Device **TC26x**
Marking/Step **ES-BC, BC**
Package **see Data Sheet**

10212AERRA

This Errata Sheet describes the deviations from the current user documentation.

Figure 1 Message buffer transfer from Message RAM to OBF

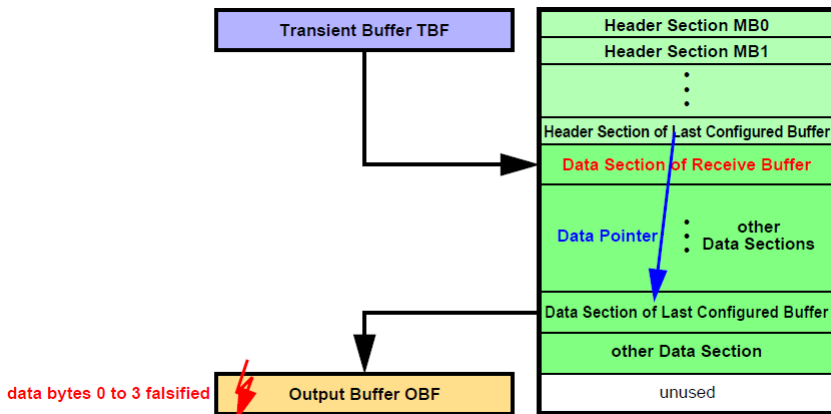
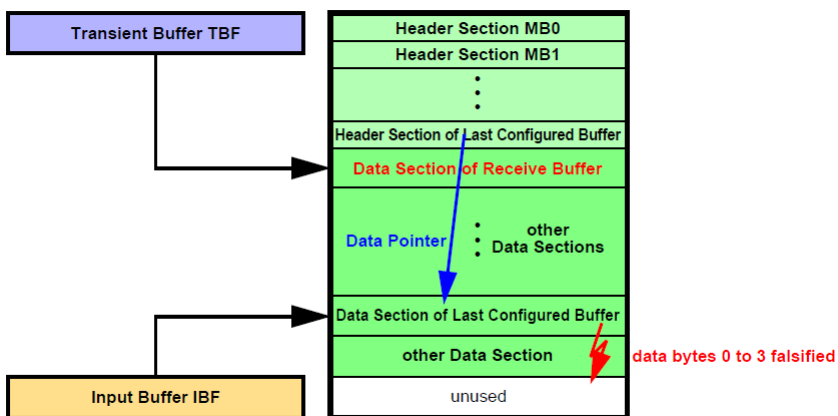
a) When a message is transferred from the Last Configured Buffer in the Message RAM to the OBF and $PLC = 127$ it may happen, that at the end of the transfer the OBF word on address 00h (payload data bytes 0 to 3) is overwritten with unexpected data (see [Figure 1](#)).

b) When a message is transferred from IBF to the Last Configured Buffer in the Message RAM, it may happen, that at the end of the transfer of the Data Section one additional write access overwrites the following word, which may be the first word of another message's Data Section in the Message RAM (see [Figure 2](#)).

Figure 3 Message RAM Configurations

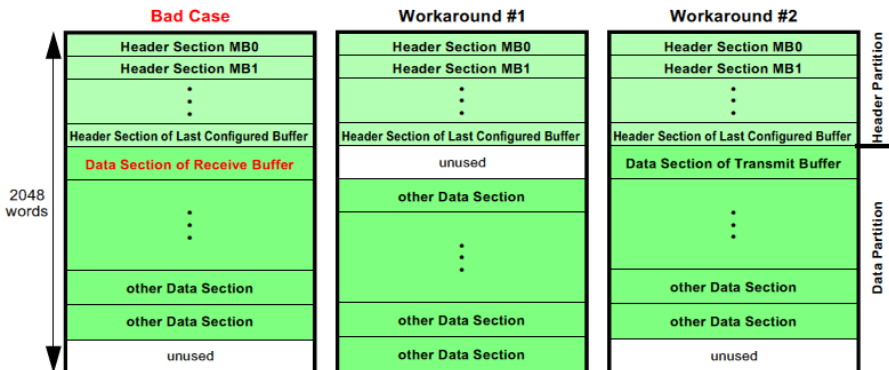
The erratum is limited to the case when (see [Figure 3](#) “Bad Case”):

2) Ensure that the Data Section directly following the Header Partition is assigned to a transmit buffer.

Figure 4 Example sequence showing how registers ETRRx may be filled with “Error Free” addresses

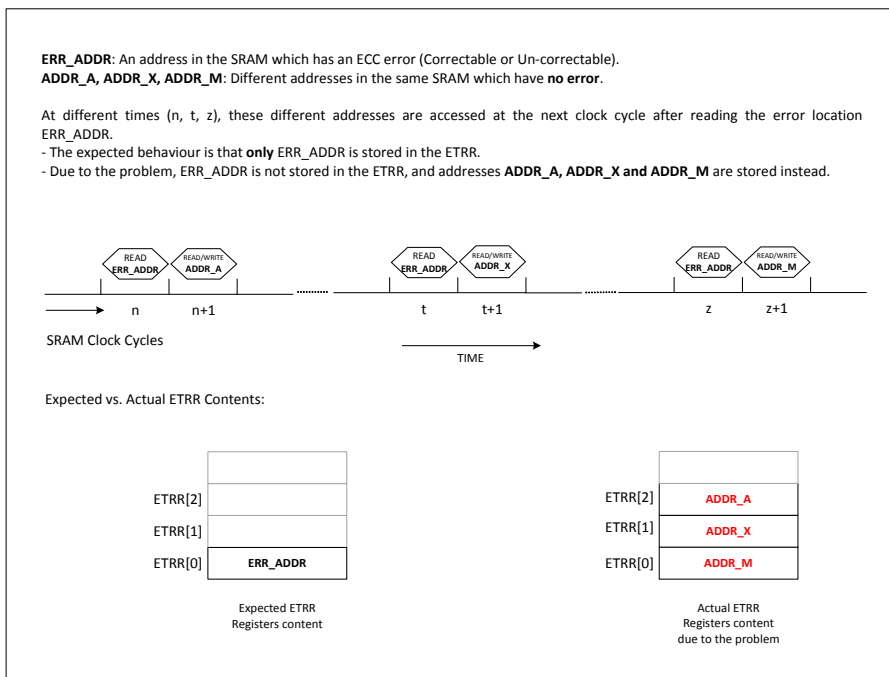
When such a consecutive access sequence (read from ERR_ADDR followed by read/write of different address(es)) happens multiple times, registers ETRRx are filled with addresses that have actually no error – and the SRAM address which actually has an error is not stored indeed. **Figure 4** shows such an example scenario.

The consequence of the scenario explained in **Figure 4** is that a single error in the SRAM – example just one correctable error at a location ERR_ADDR – can result in registers ETRRx getting filled with fault-free address, and thus potentially even triggering an ETRR overflow.

Figure 5 Recommended Software Handling - Flowchart

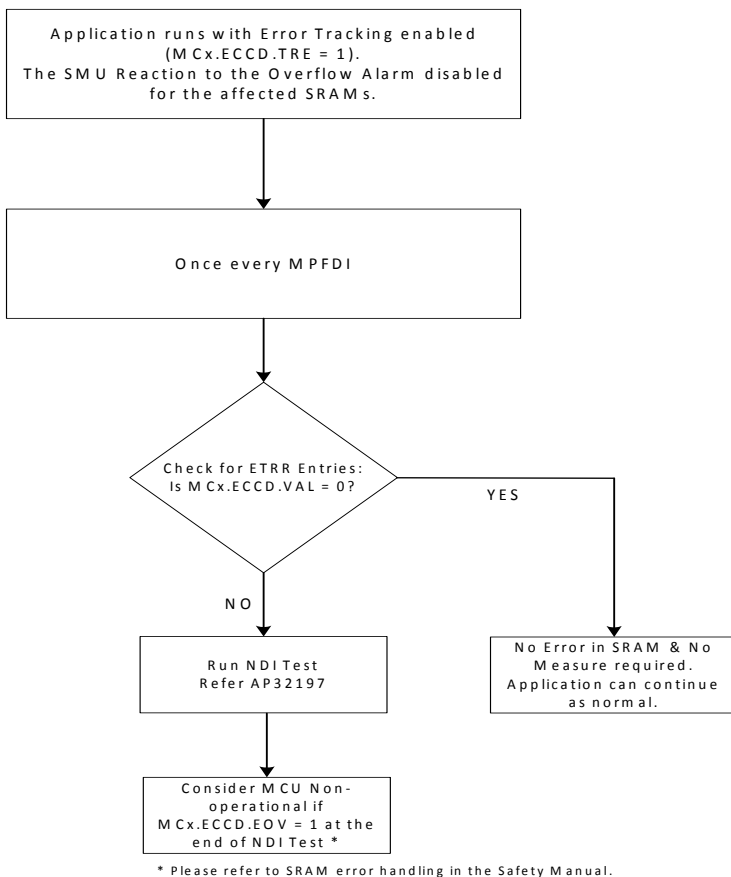
A flowchart of the recommended software handling is shown in [Figure 5](#).

If there is at least one valid ETRR entry (i.e. $MCx.ECCD.VAL \neq 0$) then the software shall run a Non-Destructive-Inversion (NDI) Test on the affected SRAM. Please refer to application note AP32197 (AURIX™ Memory tests using the MTU) for an example regarding running this test.

At the end of this test, if an ETRR overflow is detected ($MCx.ECCD.EOV = 1_B$) then the MCU shall be considered non-operational. Refer to section on Correctable SRAM Error handling in the Safety Manual.

Figure 14 Ripple Voltage vs. Frequency Characteristic

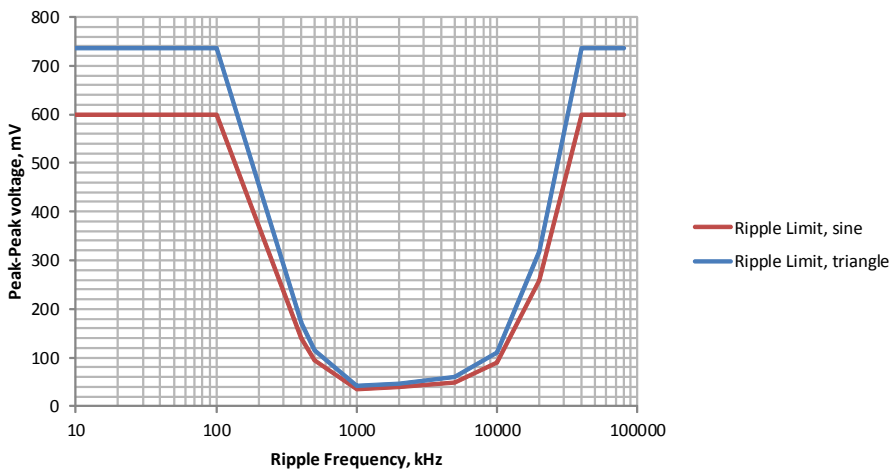
The internal back-up clock is sensitive to specific power supply voltage disturbance/ripple caused by a voltage ripple intrinsic to DC-DC converters. Specific conditions such as insufficient filtering of the ripple may lead to improper behavior of the start-up scheme of the back-up clock, and thus stuck-at state during the start-up of the microcontroller until this condition is removed.

The acceptable voltage vs. frequency characteristic is portrayed below on the chart:

The diagram reflects acceptable ripple level during the cold start of the microcontroller at the respective VDDP3/VEXT/VEVRSB supply of the PMS subsystem, depending on the device and package type, as shown in the following table.

Figure 16 SENT Tolerance of this Design Step

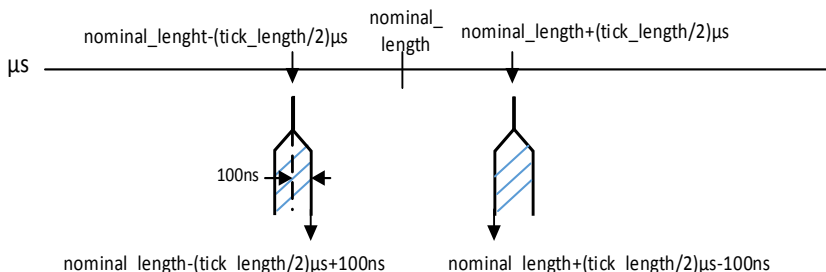
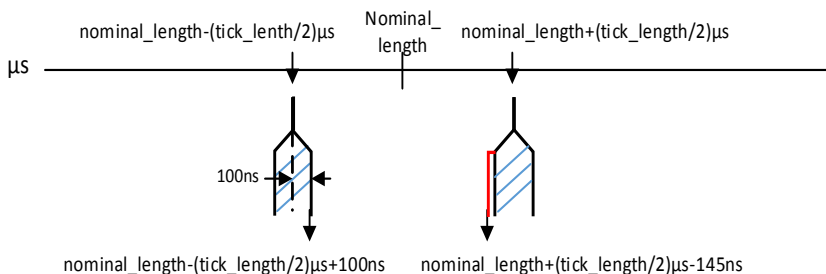
In this design step the range is delimited as follows:

- The lower border is $\text{nominal_value} - (\text{tick_length}/2) \mu\text{s} + 100 \text{ ns}$
- The upper border is $\text{nominal_value} + (\text{tick_length}/2) \mu\text{s} - 145 \text{ ns}$.

Figure 17 Short Serial Message, Serial Data Encoding over 16

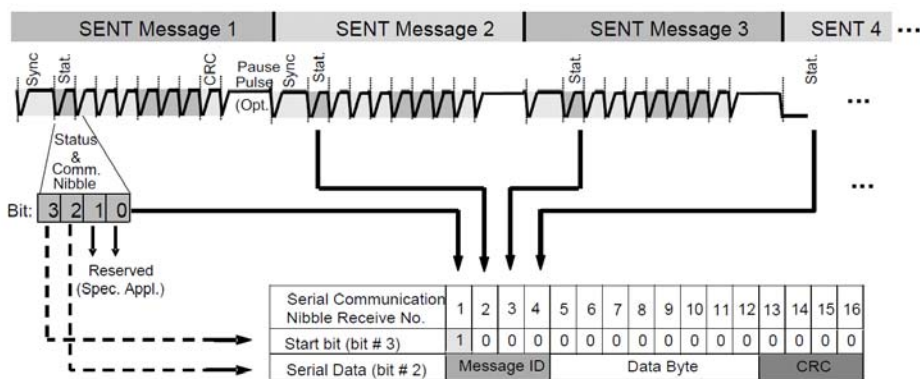
In Figure “Short Serial Message, Serial Data Encoding over 16 messages” of the SENT chapter, the arrows originating from bits 2 and 3 of the Status & Comm Nibble are routed incorrectly and must be swapped.

Figure 17 shows a corrected version of this figure.
